# PLANNING AND ZONING CASE CHECKLIST

P&Z CASE # SP2021-026 P&Z DATE 10/12/21 CC DATE \_\_\_\_\_ APPROVED/DENIED \_\_\_\_\_

PROJECT NUMBER: SP2021-026  
PROJECT NAME: Site Plan for Medical Office  
SITE ADDRESS/LOCATIONS: 505 LA JOLLA POINTE DR

**TO:** Planning and Zoning Commission  
**DATE:** October 12, 2021  
**APPLICANT:** Steven Reyes; *Architectonics Texas, LLC*  
**CASE NUMBER:** SP2021-026; *Site Plan for Medical Office*

**MATERIAL USAGE (%)**  
 ELEVATION AREA: 1429.19 SF  
 DOORS & WINDOWS: 169.9 SF 11.9%  
 MASONRY: 1260.19 SF 88.1%

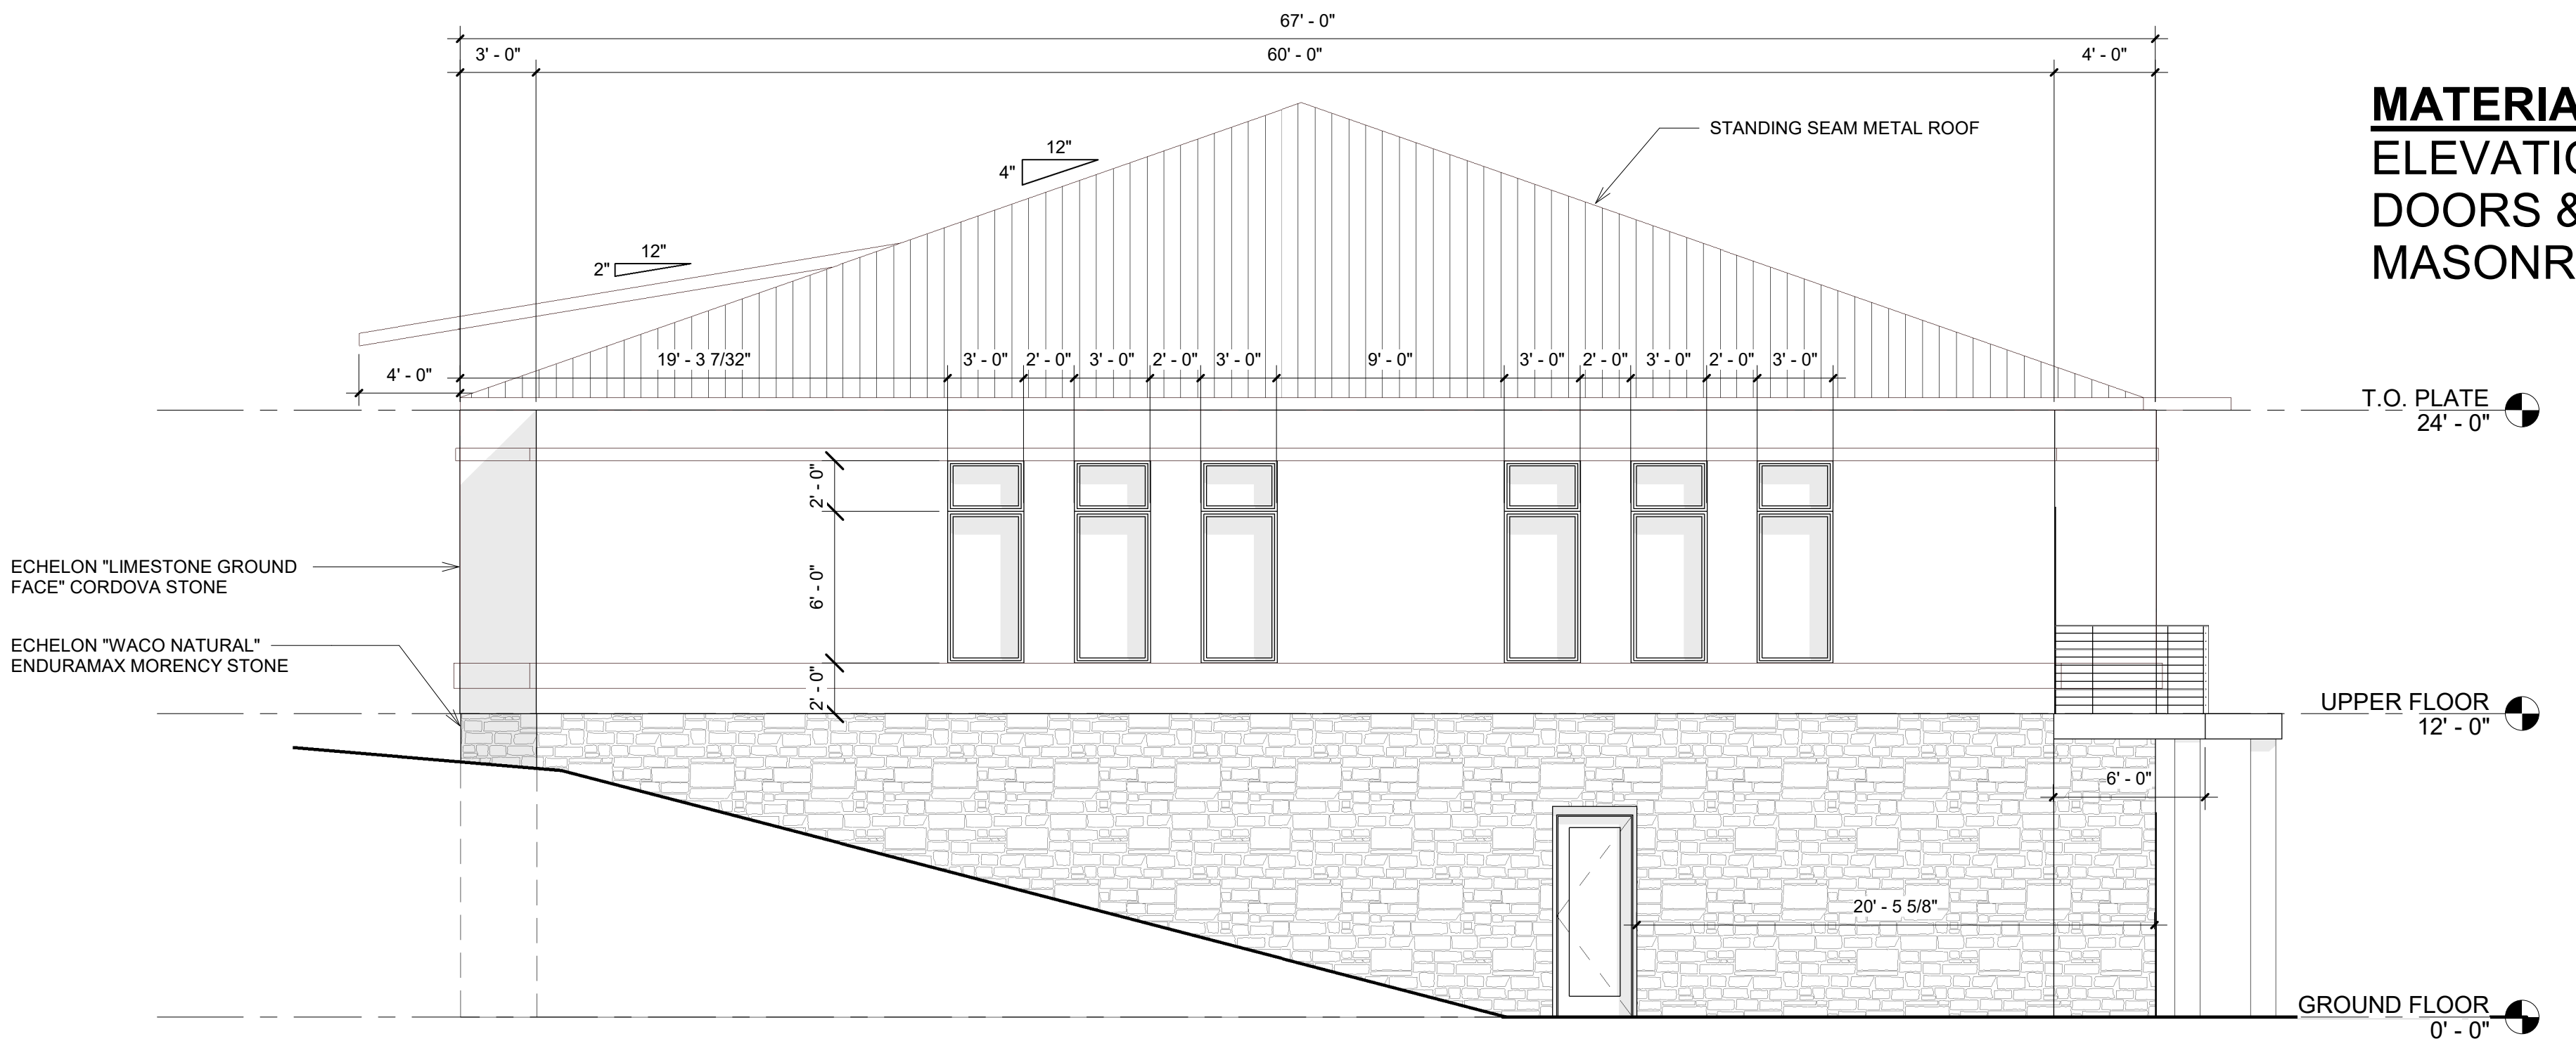
M.6 The standard signature block with signature space for the Planning & Zoning Chairman and Planning Director shall be on each page of the plans. They are currently missing from the elevations. (Subsection 03.04. A, of Article 11)

**LANDSCAPE PLAN**

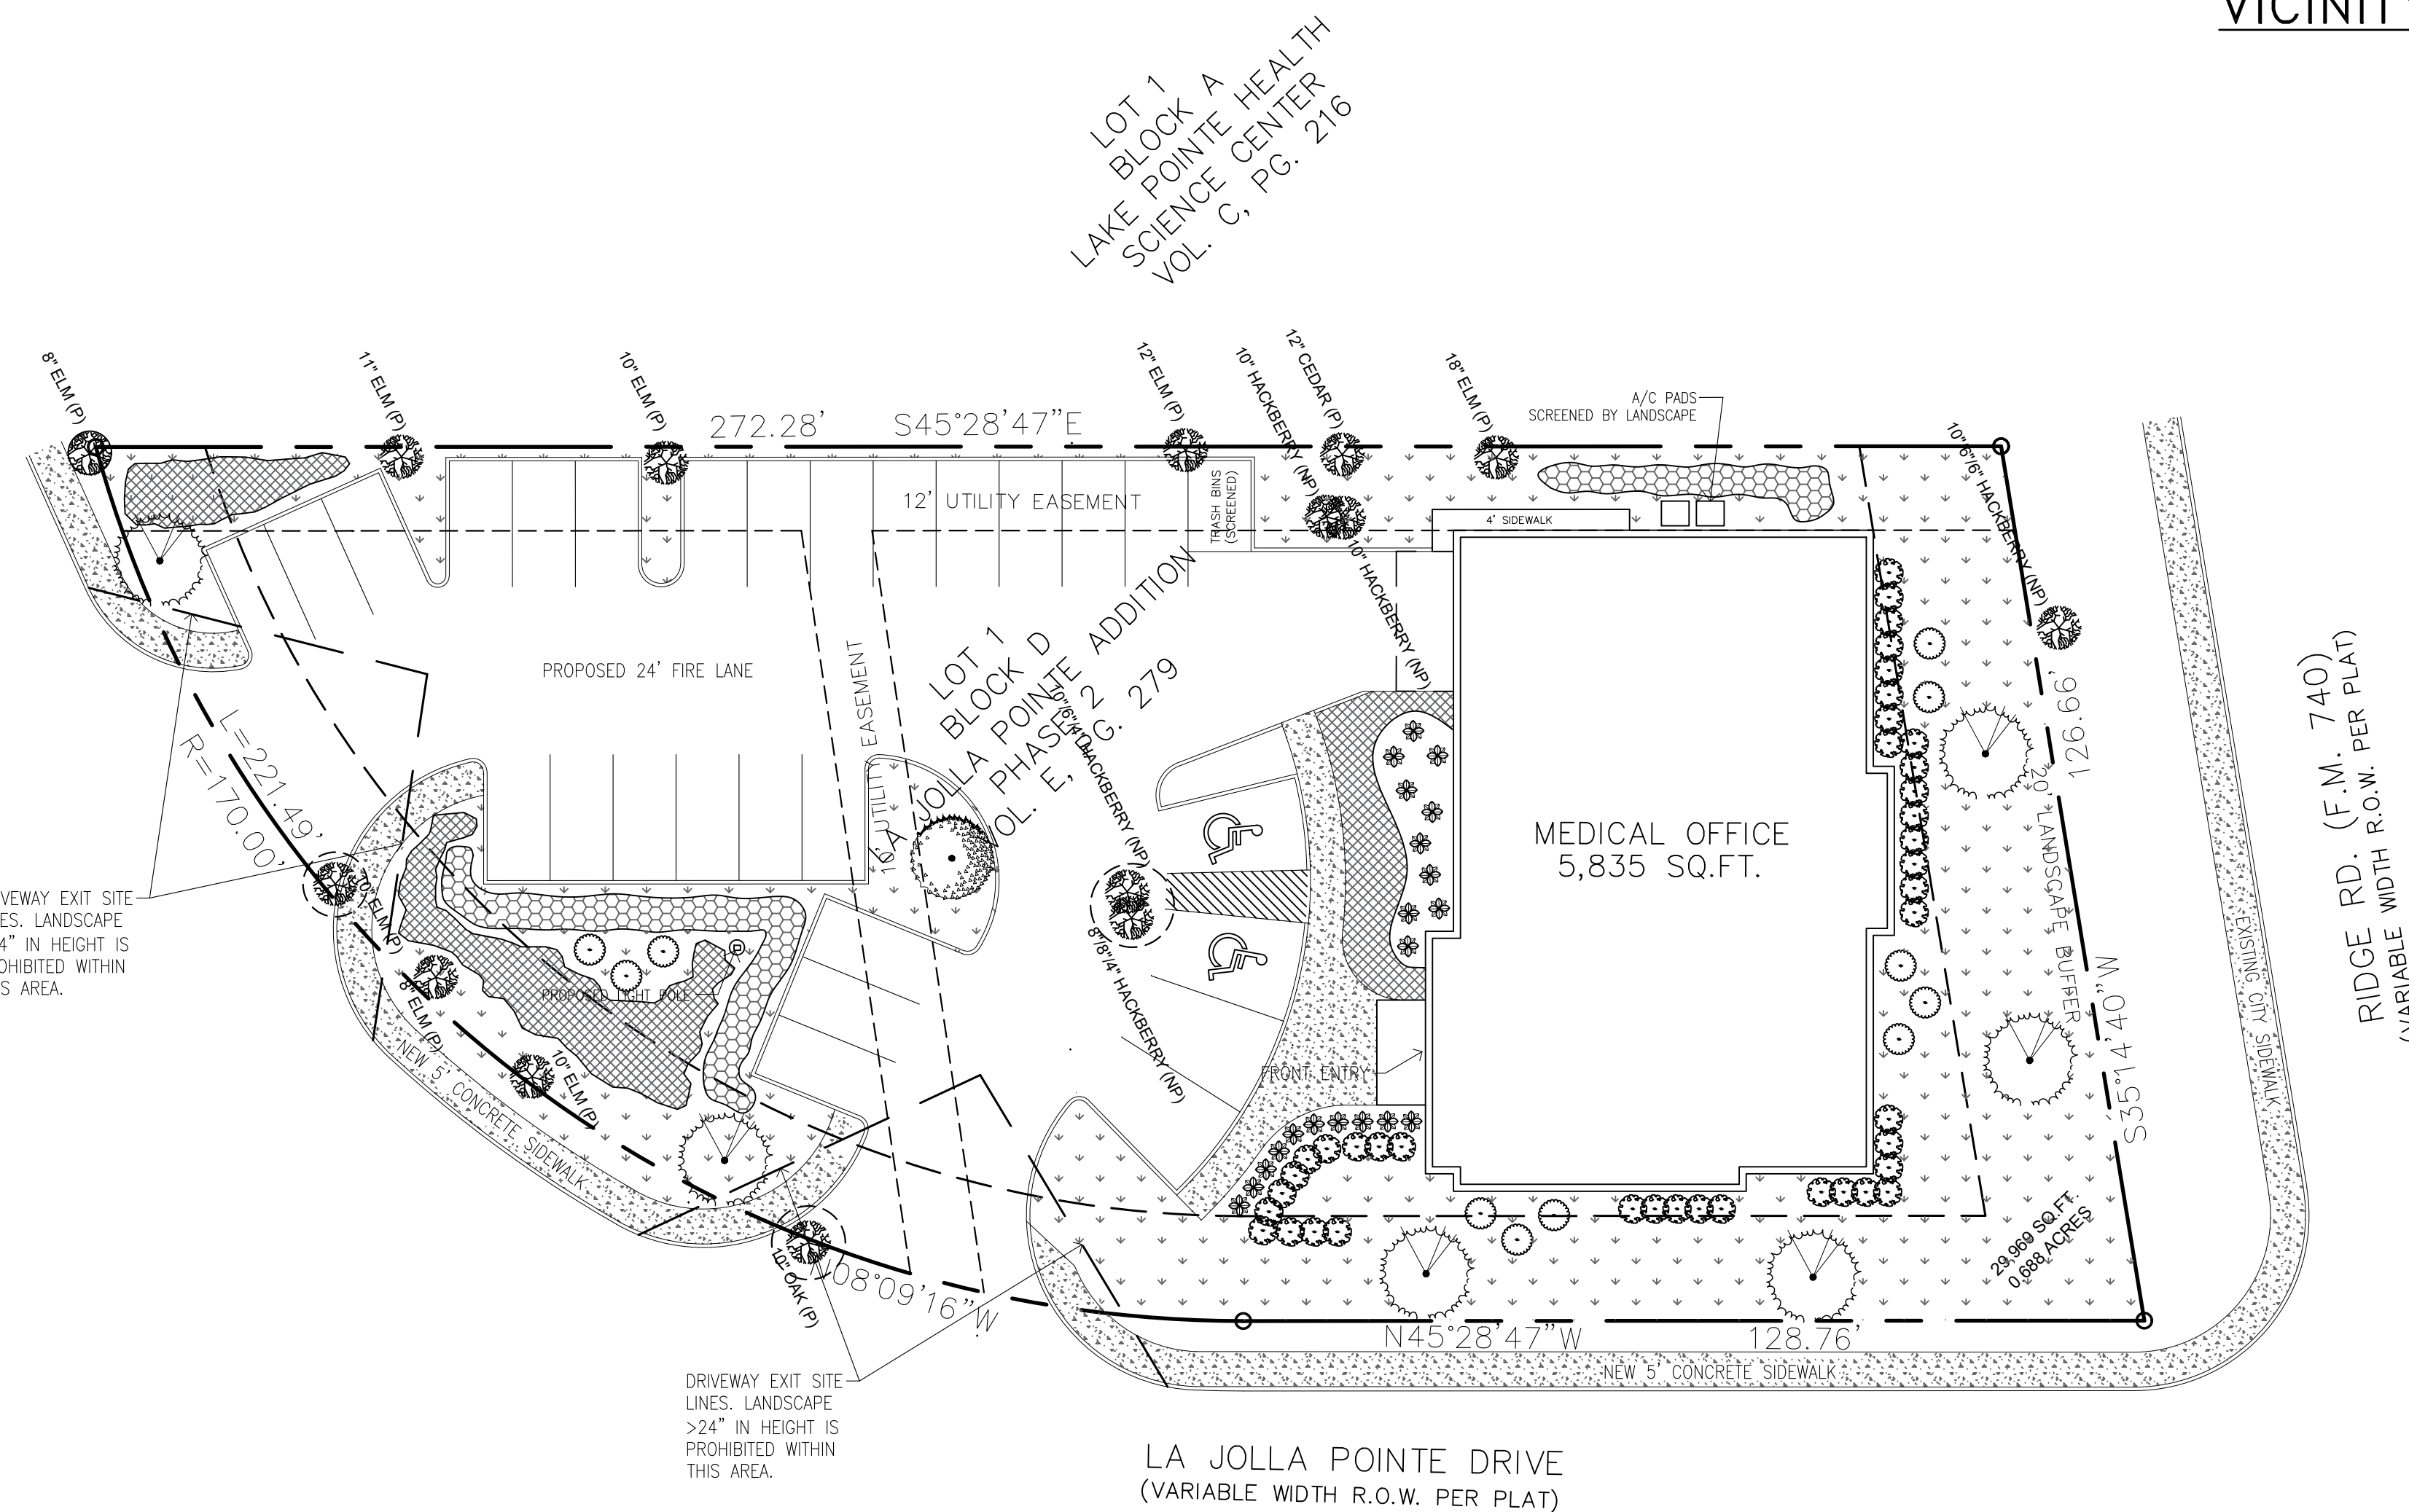
1. All canopy trees must be at least 4 caliper inches and shrubs must be at least 5 gallons. (Subsection 05.03.B, of Article 08)
2. The subject property is located in the Scenic Overlay (SOV) District and must meet the overlay district standards. In this case per 100 linear feet there must be 2 canopy trees and 4 accent trees. Therefore, along Ridge Road there needs to be 3 canopy trees and 6 accent trees. Along La Jolla Pointe there must be 6 canopy and 12 accent trees. Within the landscape buffer there must also be a berm with shrubs, which should be indicated on the landscape plan. (Subsection 05.01, of Article 08)

3. Confirm with our Engineering Department to ensure that all trees are planted away from any public utilities. (Subsection 05.01, of Article 08)
4. All parking should be within 80-feet of a canopy tree (Subsection 05.03, E. of Article 09). Please provide an exhibit demonstrating conformance to this requirement.

1. Landscape plans should show required versus proposed for parking and site, not just frontage.
2. The trees being saved; what time of Elm (Cedar, American, Siberian) also need the health of the trees to be counted towards required.
